CITY OF SAN ANTONIO

Re: Cedar Creek

MDP # 741

CEDAR CREEK SOUTH (UNITS 1, 2, 3 & 4) MASTER DEVELOPMENT & P.U.D. PLAN

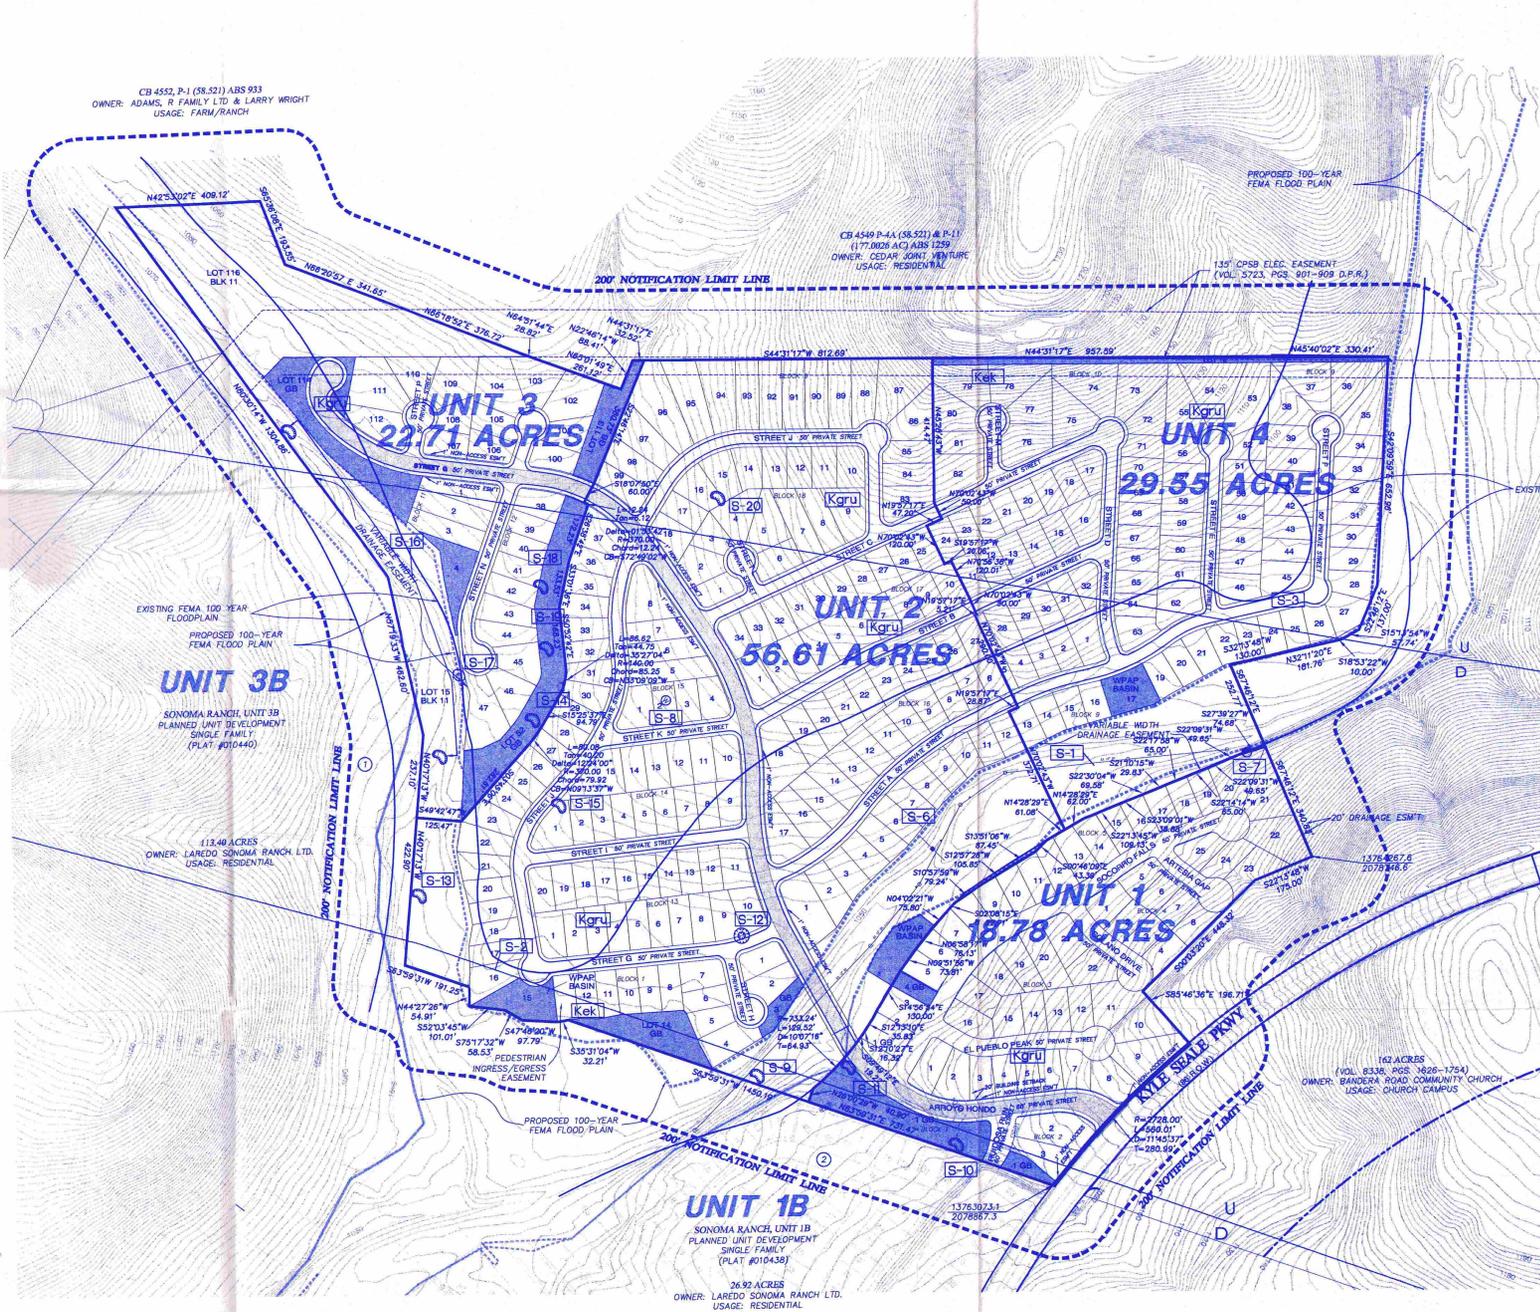
The City Staff Development Review Committee has reviewed Cedar Creek Master Development Plan M.D.P. # 741. Please find enclosed a signed copy for your files. Your plan was accepted, however please note the following:

- In consideration of public safety and convenience, excessive grades by reason of topography should be avoided in street layouts and arrangements.
- Any access and R.O.W. issues along state facilities will need to be resolved with the Texas Department of Transportation (TXDOT). For information about these requirements you can contact TXDOT at 615-5814.
- This development will need to comply with tree preservation ordinance #85262. For information about these requirements you can contact Building Inspections at 207-7102.
- It will be expected that you will plat all of the property depicted in your Master Development Plan (M.D.P.) to include floodplains, drainage areas and open space.
- I would encourage you to work closely with the school district, so that they can plan accordingly.
